Addendum 7

Sugarcreek Water Treatment Plant and Wellfield Improvements

Addendum No. 7
June 6, 2022

FUEL STORAGE TANK CIVIL ENLARGED PLAN-SECTION

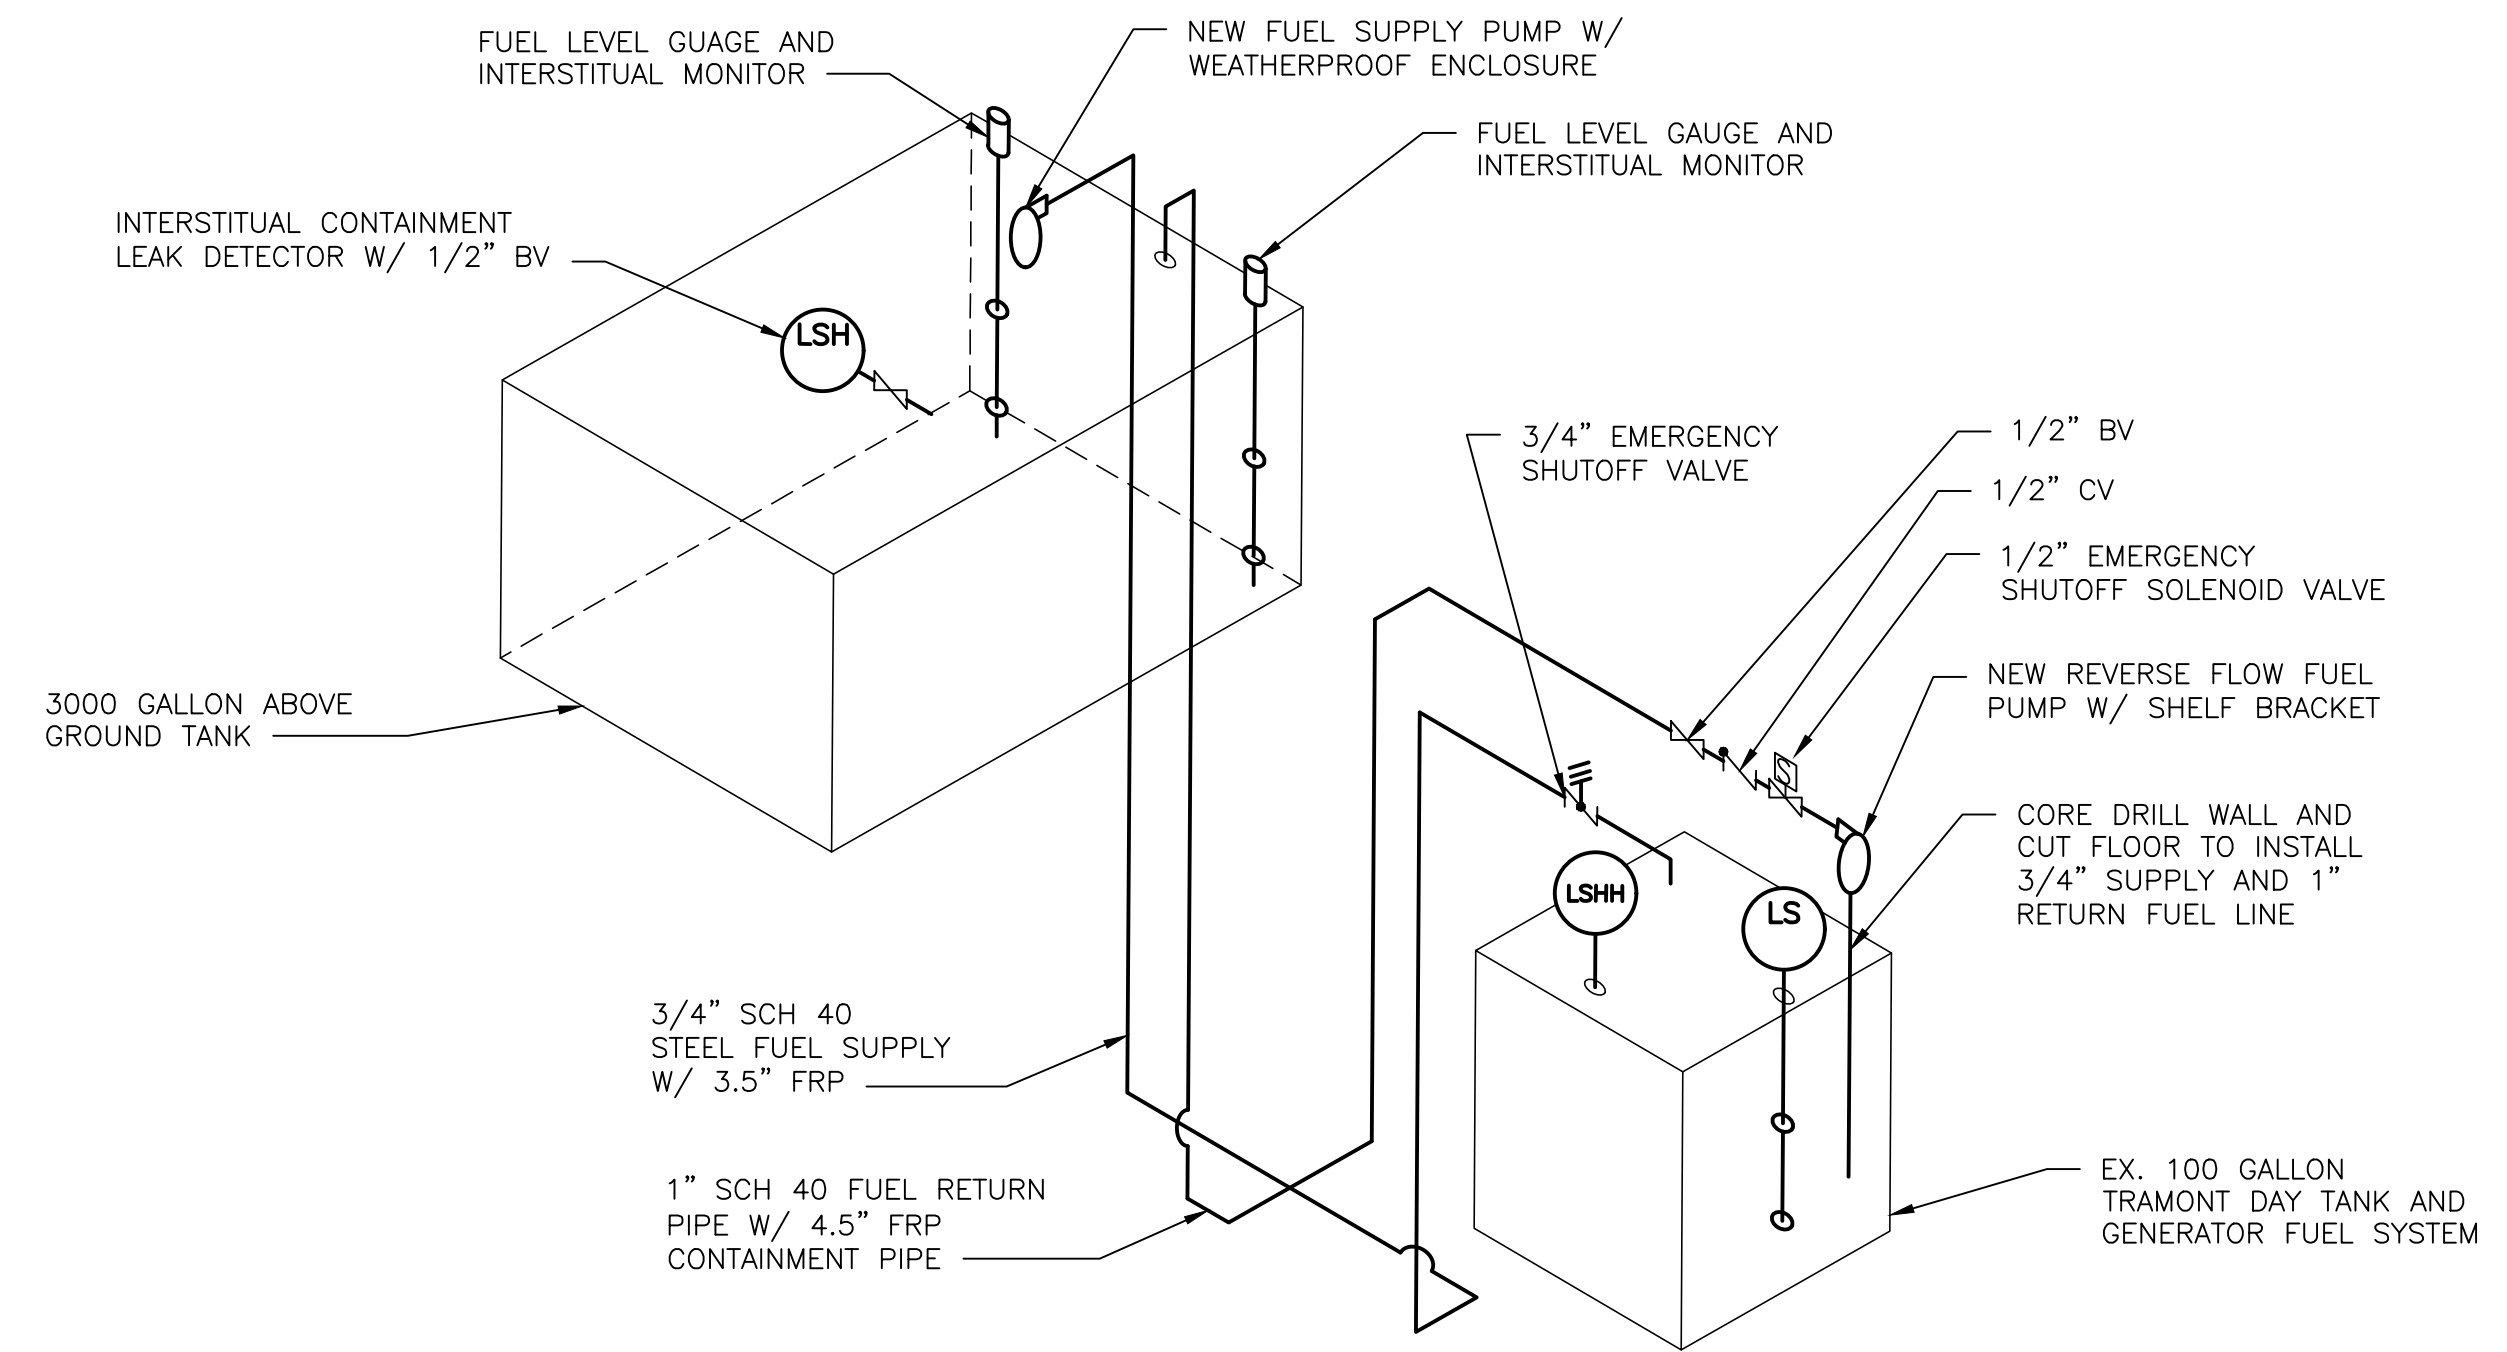
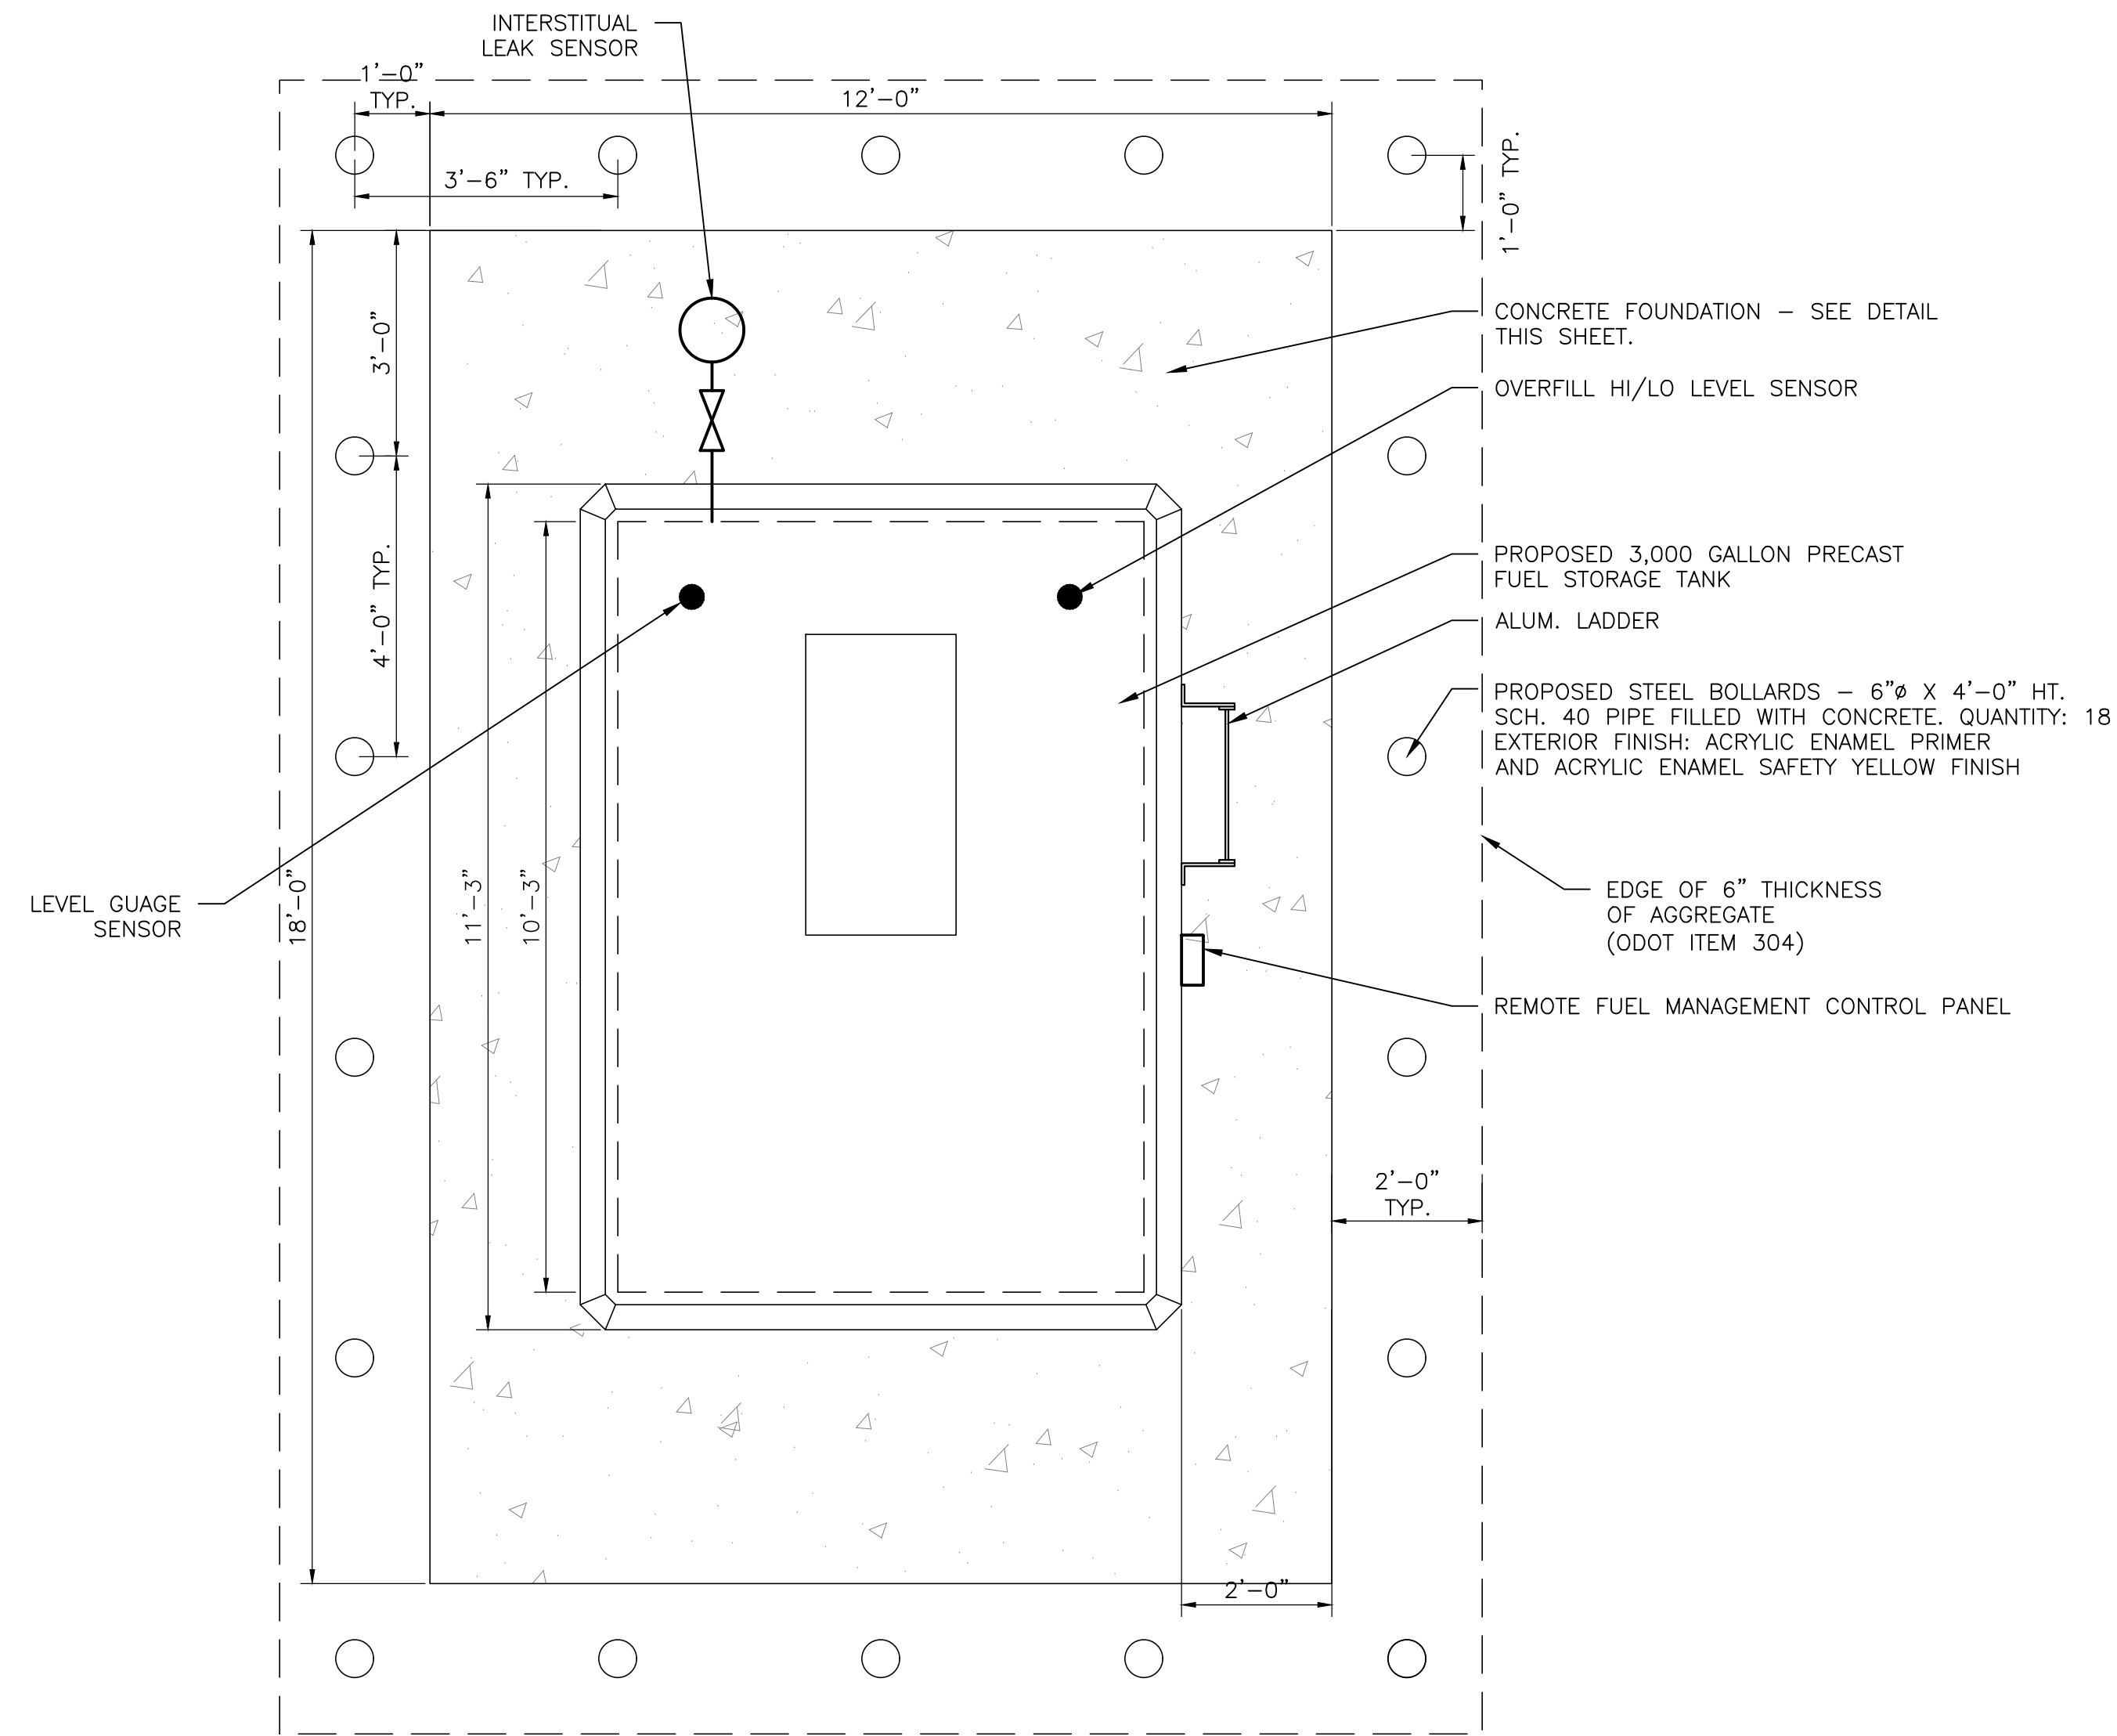
6. **Sheet C-11, Fuel Storage Tank Civil Enlarged Plan – Section.** REPLACE with the attached C-11. A piping schematic for the Aboveground Fuel Tank is included in the revised sheet to show the fuel supply and return lines to be provided in a concrete encased double containment system. A ladder and a weatherproof enclosure for a fuel supply pump were added.
